**REMARKS**

This Response is filed in response to the Office Action mailed September 9, 2005. Claims 1-32 are pending in this application. Claims 1-32 were rejected by the Office Action mailed September 9, 2005. Claims 23 and 27 were rejected under 35 U.S.C. § 112 for lack of antecedent basis. Claims 1-3, 5-10, and 12-32 were rejected under 35 U.S.C. § 102(e) as being anticipated by US Patent No. 6,002,184 to Delson et al (hereinafter "Delson"). Claims 4 and 11 were rejected under 35 U.S.C. § 103(a) as being unpatentable over Delson in view of the application's admitted prior art. Claims 10, 20, 29 and 30 were objected to for informalities in the claim language.

**AMENDMENTS TO THE DRAWINGS**

FIG.2

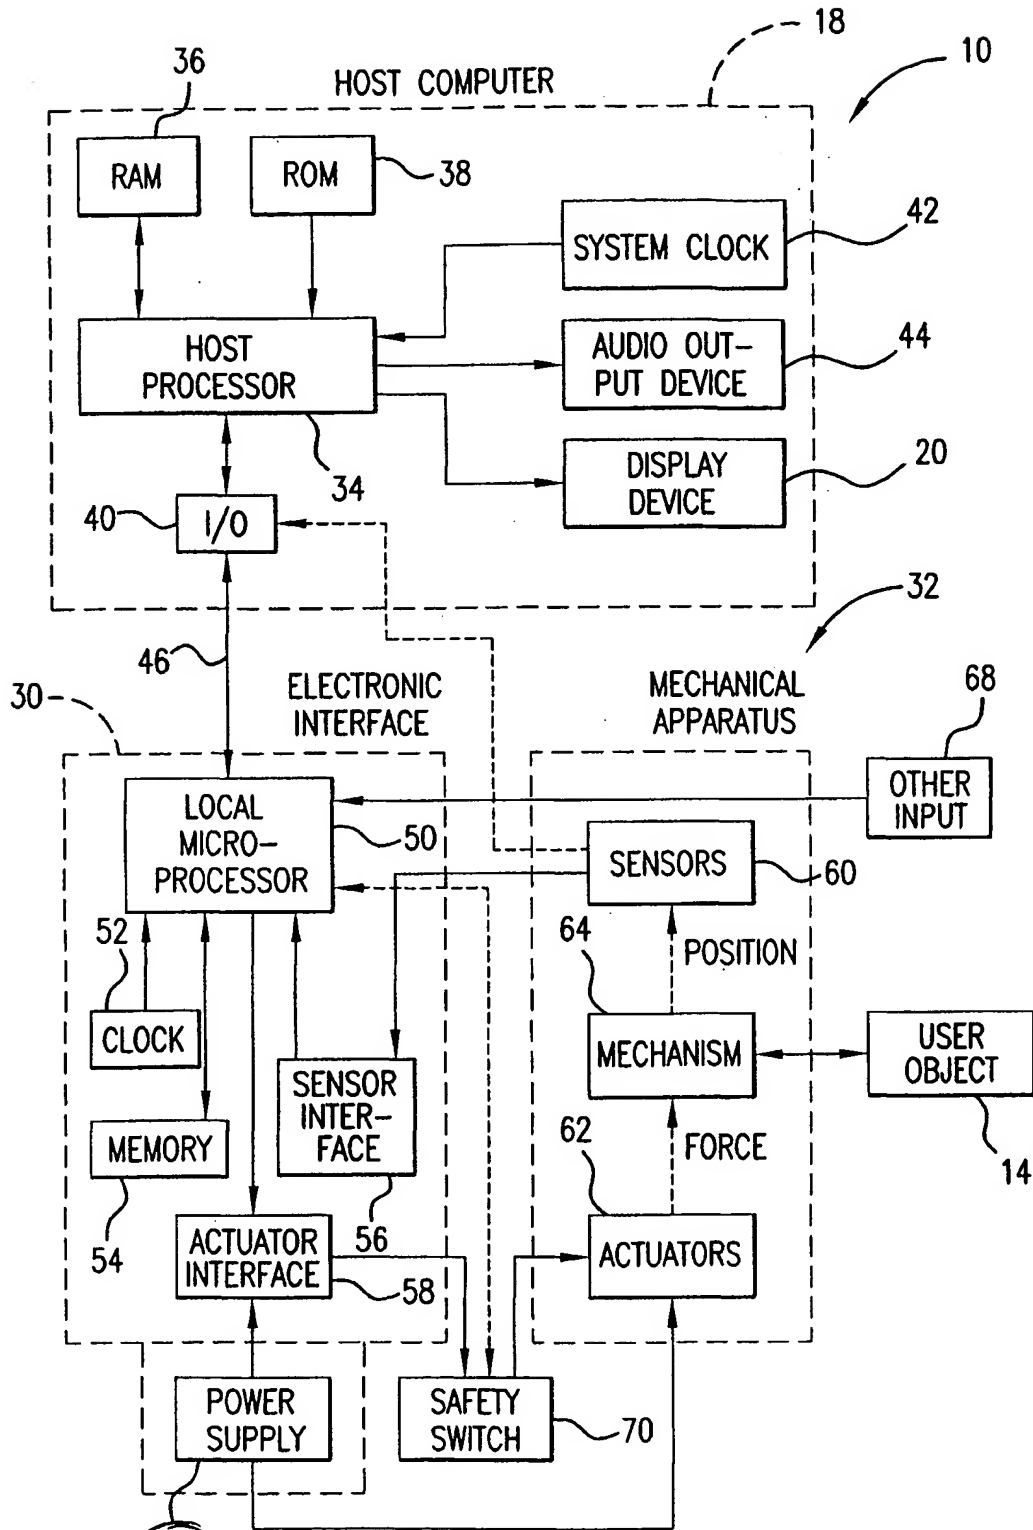
The Examiner objected to Figure 2 for failing to include label 59 that was referenced in paragraph 32 of the specification. Applicant has amended Figure 2 to include previously omitted element label 59.

In Figure 2, previously omitted element label 59 that is found in paragraph 32 of the specification has been added.

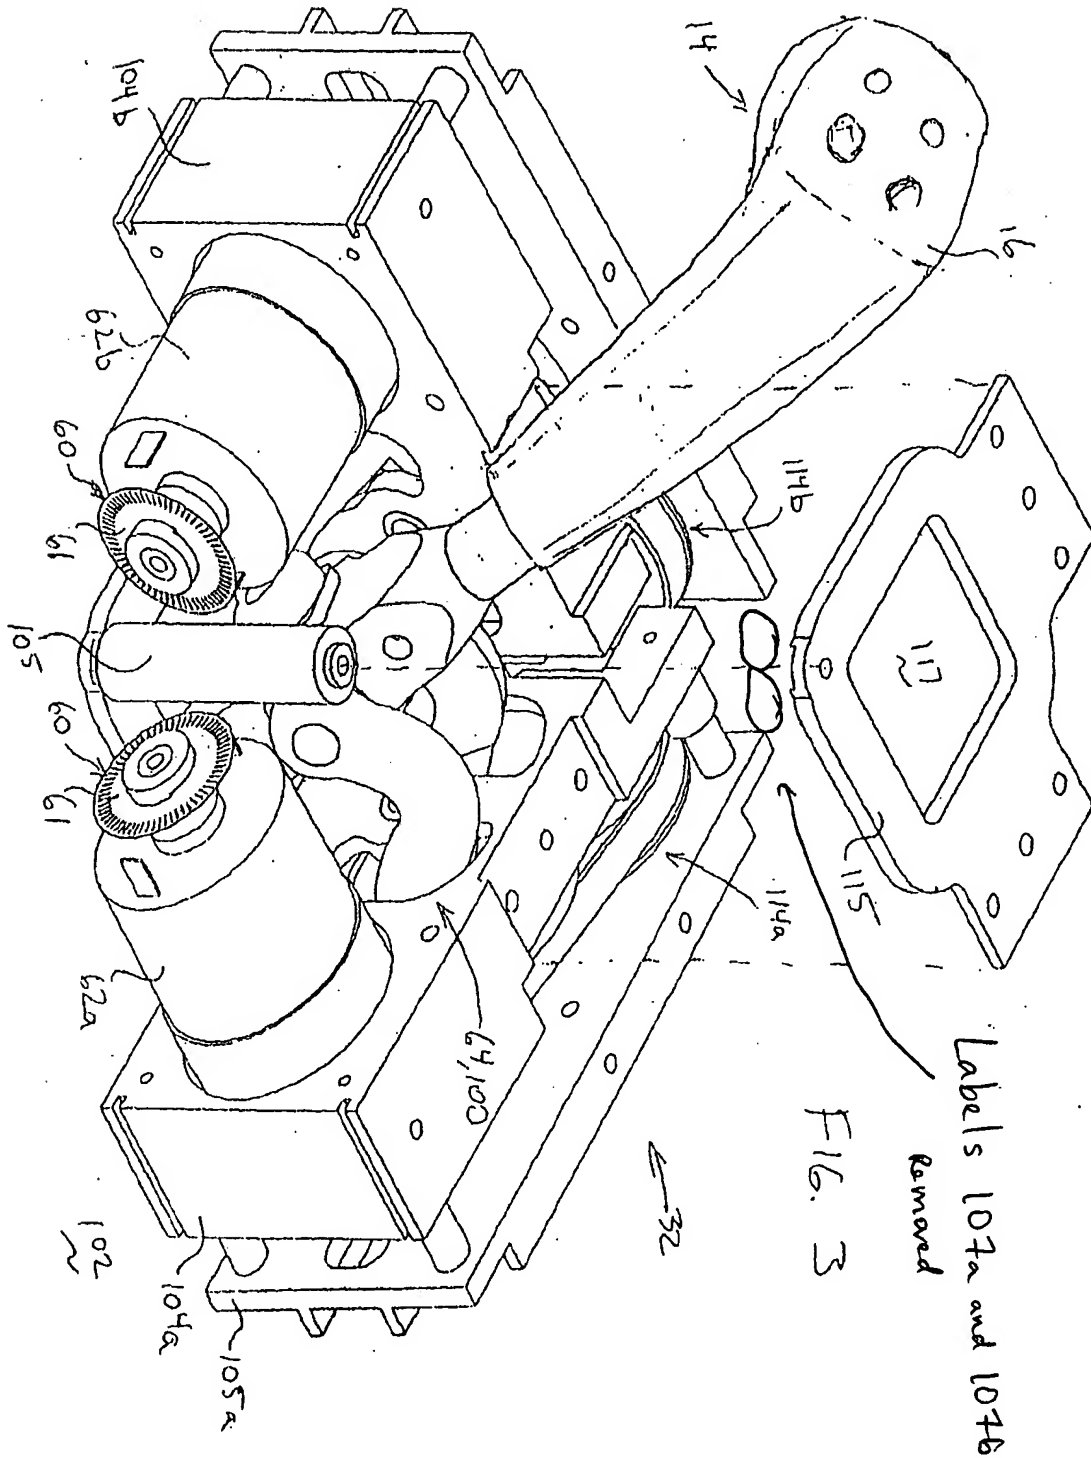
The Examiner objected to Figure 3 for including labels 107a and 107b that were not referenced in the specification.. Applicant has amended Figure 3 to remove previously included element labels 107a and 107b.

In Figure 3, previously included element labels 107a and 107b that were not referenced in the specification have been removed.

FIG.6

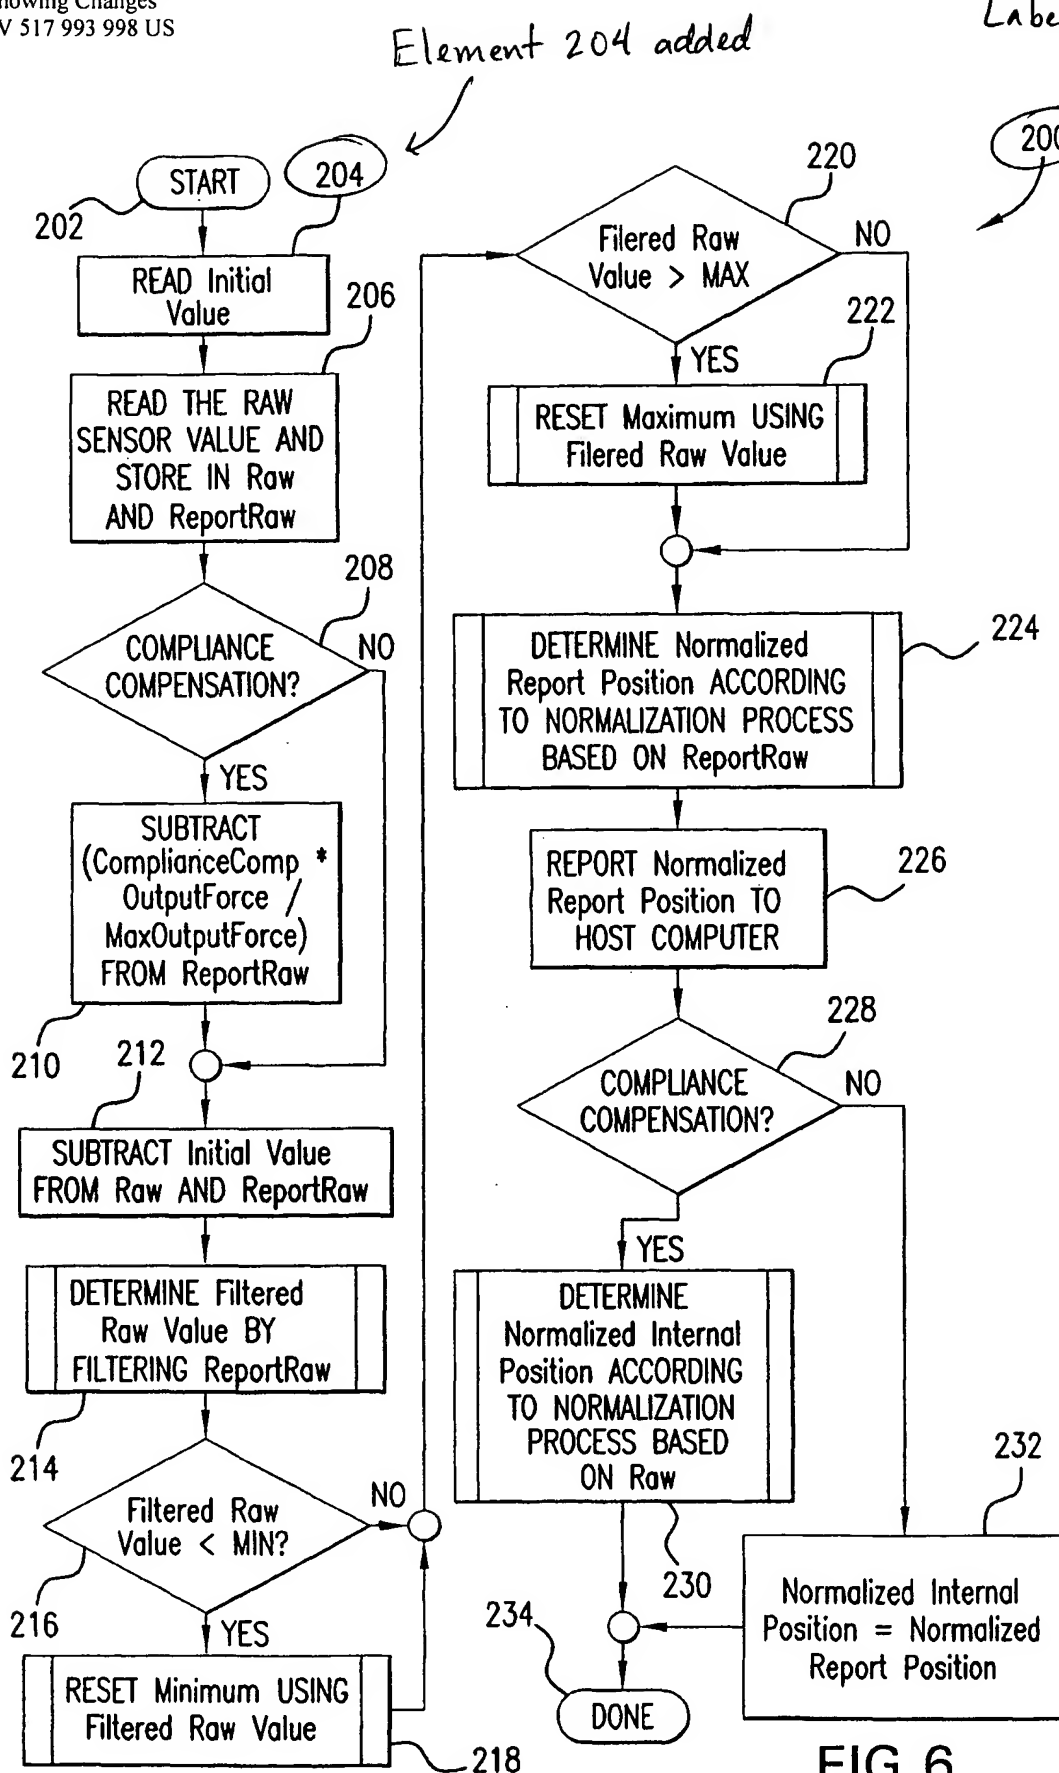
The Examiner objected to Figure 6 for failing to include labels 200 and 204 that were referenced in paragraphs 64 and 68, respectively, of the specification. Applicant has amended Figure 6 to include previously omitted element label 200 and previously omitted element 204.

In Figure 6, previously omitted element label 200 and element 204 that are found in paragraphs 64 and 68, respectively, of the specification have been added.

FIG. 10

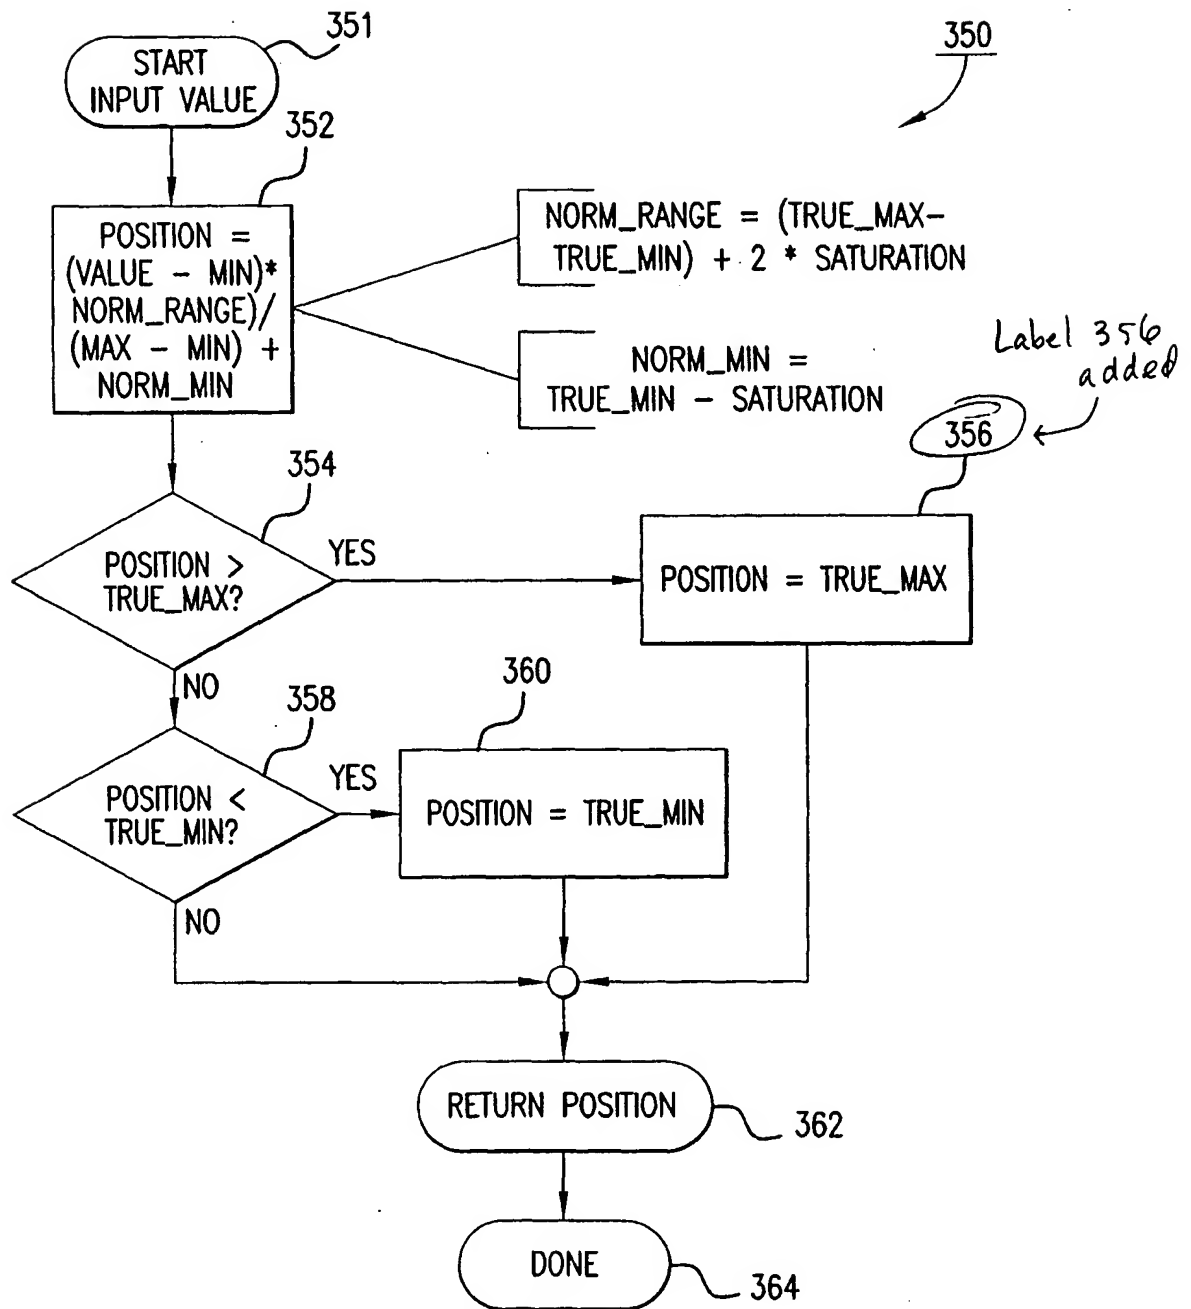
The Examiner objected to Figure 10 for failing to include label 356 that was referenced in paragraph 86 of the specification. Applicant has amended Figure 10 to include previously omitted element label 356.

In Figure 10, previously omitted element label 356 that is found in paragraph 86 of the specification has been added.
